**FINAL PRODUCT/PROCESS CHANGE NOTIFICATION # 20461**Generic Copy

**Issue Date:** 28-Apr-2014**TITLE:** Qualification of ON Semiconductor Vietnam (OSV) for the Assembly and Test of Trench IGBT and a transition to a new case outline of Rectifiers devices for package TO247.**PROPOSED FIRST SHIP DATE:** 28-Jul-2014**AFFECTED CHANGE CATEGORY(S):** ON Semiconductor Assembly & Test**FOR ANY QUESTIONS CONCERNING THIS NOTIFICATION:**Contact your local ON Semiconductor Sales Office or following contact Product Engineer:  
Raja Roziah Raja Rahmat <[Raja.Roziah.Rahmat@onsemi.com](mailto:Raja.Roziah.Rahmat@onsemi.com)>**SAMPLES:** Contact your local ON Semiconductor Sales Office**ADDITIONAL RELIABILITY DATA:** AvailableContact your local ON Semiconductor Sales Office or Reliability Engineer Chean Ching Sim  
<[cheanching.sim@onsemi.com](mailto:cheanching.sim@onsemi.com)>**NOTIFICATION TYPE:**

TO-247  
CASE 340L-02

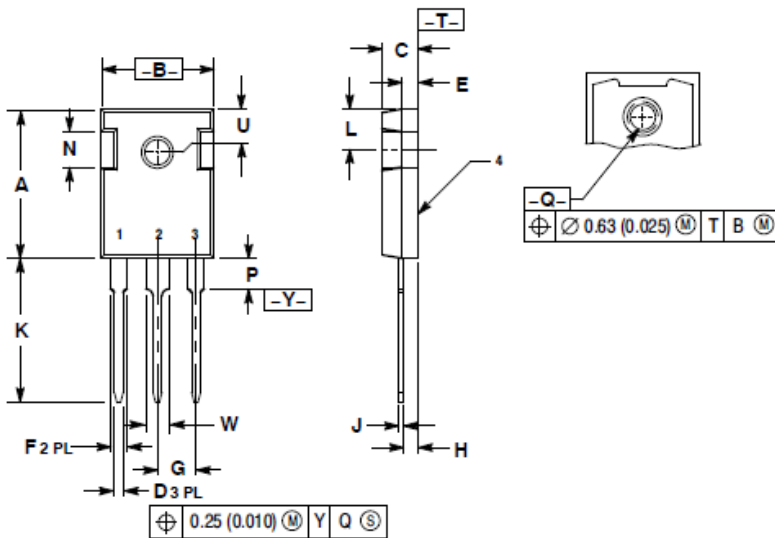
Legacy rectifier products will transition to a new case outline as a part of this capacity expansion. Case outline 340L-02 will transition to 340AL. This does not impact the IGBT devices listed in this FPCN.

**Comparison between case outline**
